PLANNING COMMISSION MEETING

September 17, 1987

RE: Darrell Nielsen
 Gravel Excavation

PRELIMINARY REVIEW
DARRELL NIELSEN GRAVEL EXCAVATION

Fig. 3.7.3 Angle of repose.

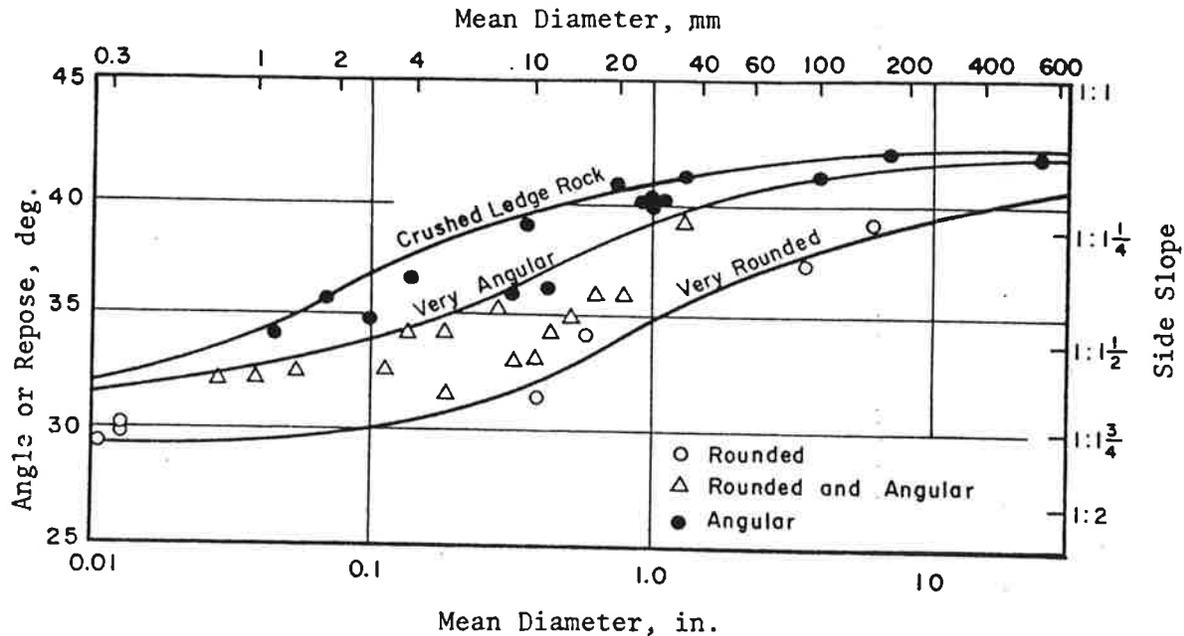
The proposed slopes of 2:1 are steeper than the natural angle of repose for this area. The ground surface lies at about 4 to 1. Increasing the exposed slope to a 2:1 will result in erosion that will result in washes and ravines with the transported materials being deposited in what is proposed to be a future retention basin. The erosion will migrate uphill creating scars that will be visible from essentially all areas. The erosion will continue until bedrock is encountered and/or the basin is full and the slope re-established at 4:1 more or less.

- 6- "THE ANGLE OF REPOSE IS THE MAXIMUM SLOPE ANGLE UPON WHICH NON-COHESIVE MATERIAL WILL RESIDE WITHOUT MOVING". IN MATERIAL FROM ANGULAR CRUSHED LEDGE ROCK THRU FINE ROUNDED SAND, THE ANGLE OF REPOSE VARIES FROM ABOUT 29° (APPROX. 1 3/4:1) TO ABOUT 41½° (APPROX. 1 1/10:1). U.D.O.T. PERSONNEL STATE THAT THE SIDE SLOPES IN THE CLEAN GRAVEL CUT ABOVE FIFE ROCK PRODUCTS ON THE STATE ACCESS ROAD TO LOGAN VARY FROM 1½ TO 1 TO 2:1. THIS CUT HAS EXISTED FOR SEVERAL YEARS AND SHOWS VERY LITTLE MOVEMENT OR SLOUGHING.

ATTENTION IS ALSO INVITED TO BOX ELDER CANYON WHERE THE CUT SECTIONS FOR THE HIGHWAY ARE IN MANY LOCATIONS AS STEEP AS 1½ TO 1. NO ARTIFICIAL PLANTING WAS DONE DURING THE ROAD CONSTRUCTION, HOWEVER, BOTH SIDES OF THE CANYON EXHIBIT EXTENSIVE FLORA. ATTENTION IS ALSO DRAWN TO THE PLANTING IN THE FIFE PIT (WHICH IS GRADED TO A SLOPE OF 2:1). PICTURES HAVE BEEN PREVIOUSLY SUBMITTED. THIS PLANTING APPEARS TO BE HIGHLY SUCCESSFUL.
